12 August 2022

Re: SSD-5285-Mod-1: Balranald Mineral Sands Mine Extension of underground mining trial

This letter responds to the traffic related matters raised by Transport for NSW's (TfNSW) agency ¹submission on Iluka Resources Limited (Iluka) proposed modification to State Significant Development (SSD) 5285 for the Balranald Mineral Sands Mine Extension of underground mining trial.

Figure 2.1 Austroads warrant design charts for rural intersection turning lanes

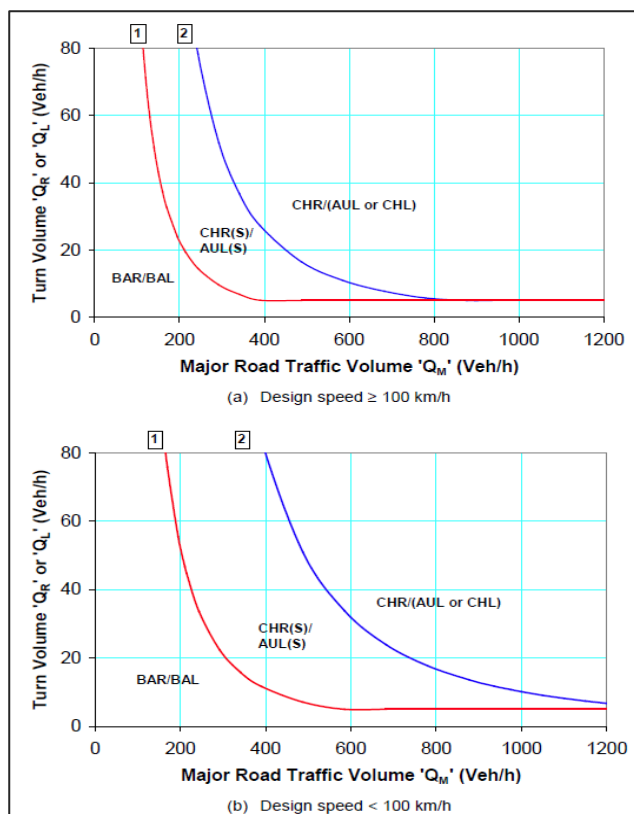
- TIA conclusions are based on traffic volumes only and does not consider vehicle types.
- TfNSW does not support the proposed changes to the approved conditions due to consideration of traffic volume composition (ie high proportion of laden heavy vehicles generated by the development and existing traffic on an approved road-train route), and the signposted speed environment (eg 100 km/h on the highway and major roads).
- It is unclear as to whether haulage of any material off-site has occurred since the SSD-5285 consent was granted.

Based on the revised traffic volumes for MOD1, updated intersection warrant assessments were undertaken for the three affected intersections in accordance with Austroads Guide to Road Design Part 4, Intersections and Crossings General 2017b (Figure 2.1).

It should be noted that Austroads Guide to Road Design Part 4: Intersections and Crossings – General (Section A.8) states that:

“Traffic flows applicable to the warrants are peak hour flows, with each vehicle counted as one unit (i.e. do not use equivalent passenger car units [pcus])”

Therefore, Austroads turn warrant assessment is independent to vehicle type.
